TO: Ryanne Sass, Plaza Street Partners
FROM: Stacey Nerger, Senior Planner
DATE: October 11, 2022
SUBJECT: Lincoln Professional Park – Preliminary Site Plan
Review Comments 05

LINCOLN PROFESSIONAL PARK FILING NO.1 PRELIMINARY SITE PLAN

PRELIMINARY SITE PLAN

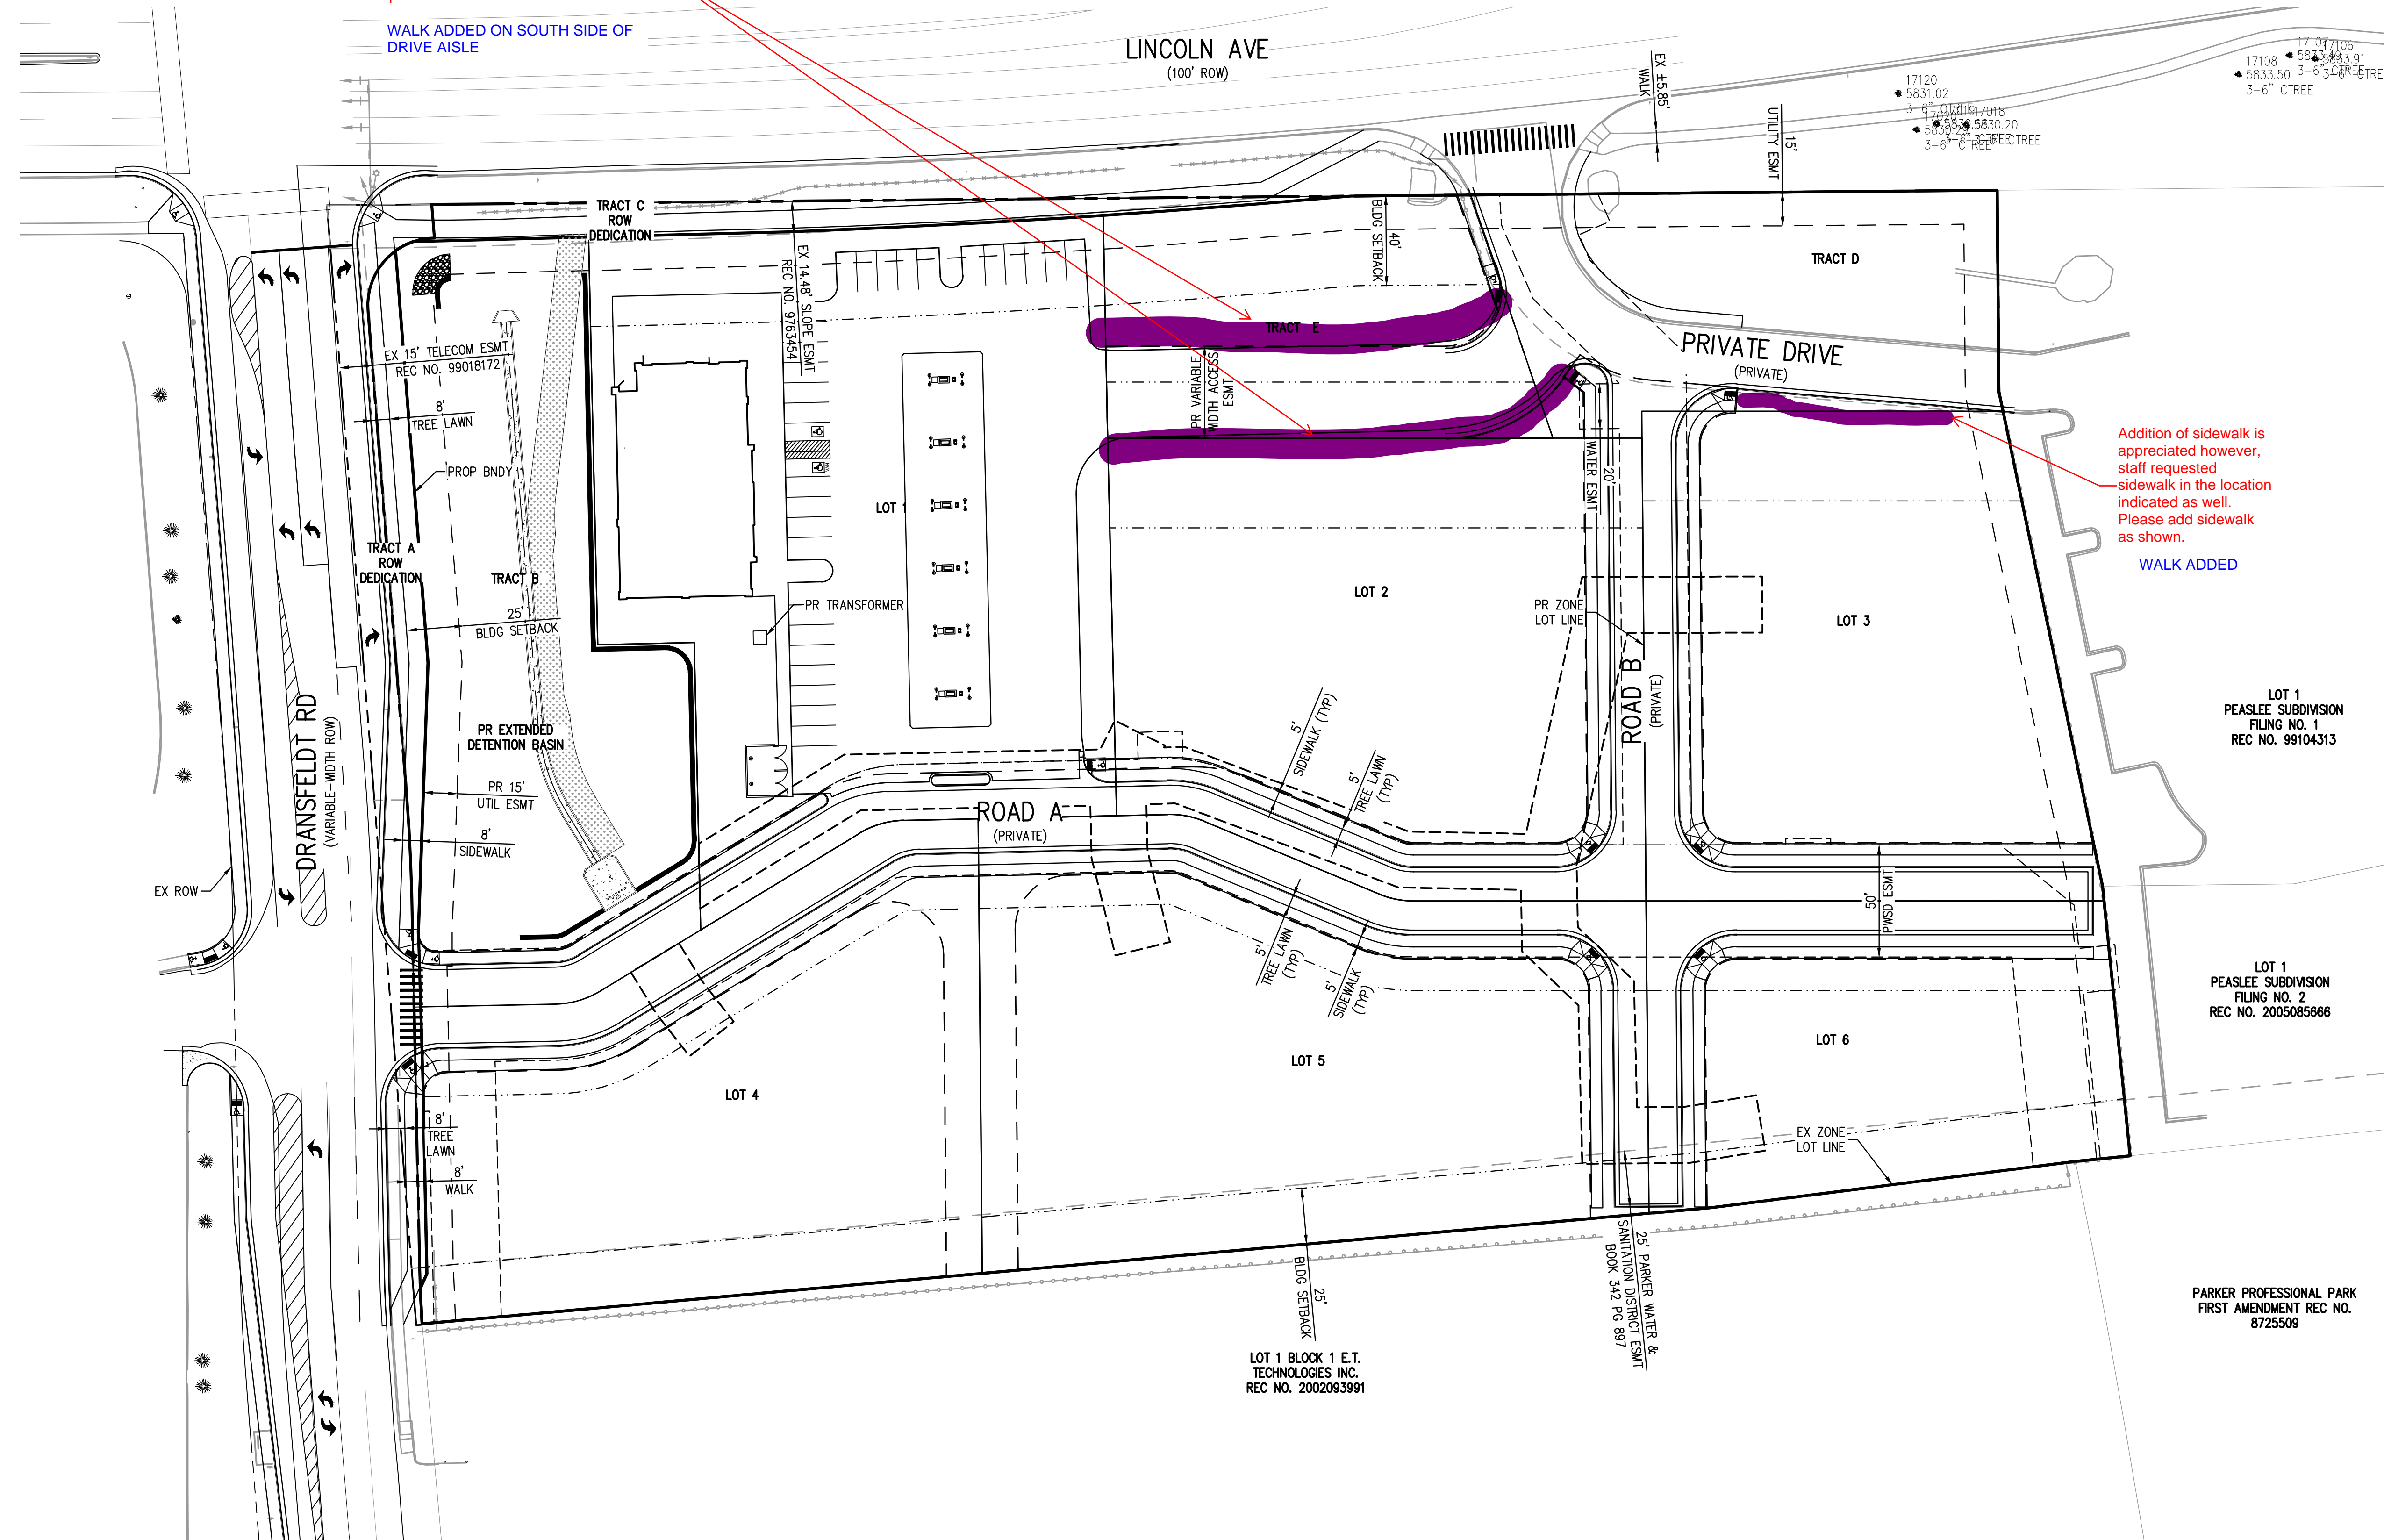
Sorry for missing this in the previous review. But please add a sidewalk to at least one side of this internal road. It may be easier to provide within Tract E.

Addition of sidewalk is appreciated however, staff requested sidewalk in the location indicated as well. Please add sidewalk as shown.

WALK ADDED ON SOUTH SIDE OF DRIVE AISLE

WALK ADDED

LANDSCAPE PLAN SHEET 3 OF 5

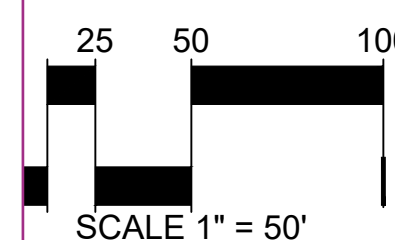
As discussed with the applicant, since this tract is not buildable. Landscaping will need to be provided at the time of MDP. The entire tract shall be landscaped. Please include a minimum of 1 tree and 5 shrubs per 1,500 sq. ft. of landscaped area. Trees and shrubs can be grouped.

Add street trees along the side of the internal road where the new sidewalk is added. Assuming it will be on the north.

Addition of sidewalk is appreciated however, staff requested sidewalk in the location indicated as well. Please add sidewalk as shown.

Due to utility conflicts shrubs were added instead. Please include a column for the number of shrubs provided. Based on the Town LDO, 10 shrubs can equal 1 tree.

Staff comment indicates these calcs should remain the same. They have increased. The response from the applicant indicates that the radii (only) have been omitted from the calculation. Staff believes these numbers should have decreased? Please clarify. Additionally, these numbers affect the minimum street tree requirement, please verify that these changes remain in compliance with street tree requirements. Verification needs to appear in writing.

Noted, tract landscaping has been provided in separate MDP application plans.

Street trees have been provided for added sidewalk at south side of drive

Sidewalk and street trees have been provided in noted location.

Table has been provided documenting shrub/grass substitutions.

Calculations have been rerun and verified as those listed in revised plans. A document breaking down various calculations and associated requirements has been provided.
